TITLE: Clamp board - 2S-3.7V rev C- 4 layer v2

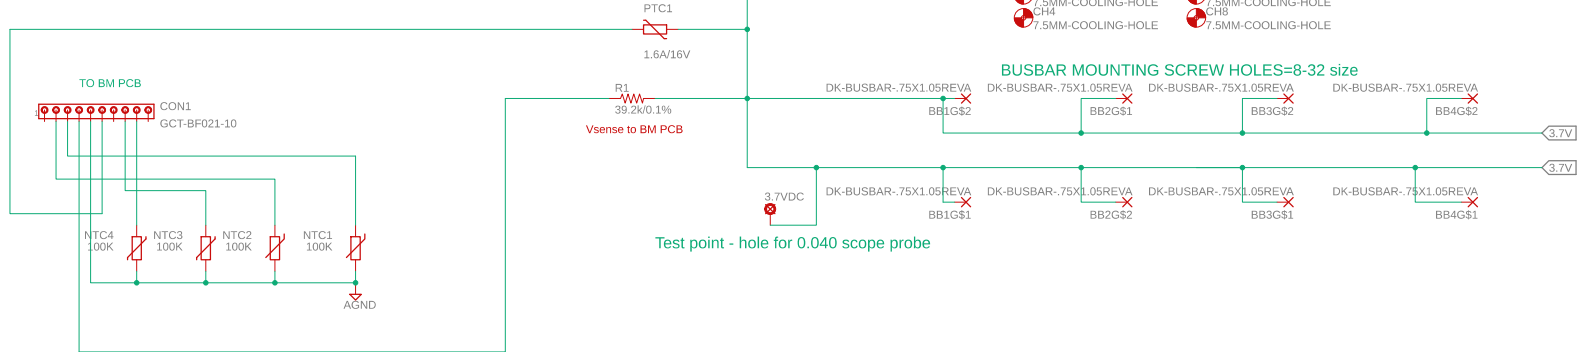
REV A:  
 1. Fatten traces from 12 to 16 mil for robustness  
 2. Change clearance around PCB mounting screw from 0 to 7.2mm restricted zone  
 3. was 2 layer is 4 layer, bot layer small signal  
 4. Connect 3.7V to CONN  
 5. Make new Busbar part - install on PCB  
 6. Make new spring finger part and install on PCB  
 7. Add PTC fuse protection on 3.7V wires  
 8. Mark on board where both clamp boards and BM board line up

PCB MOUNTING SCREW HOLES=4-40 for truss head screw  
 MAKE SURE THERE IS 7.2mm dia with no copper!
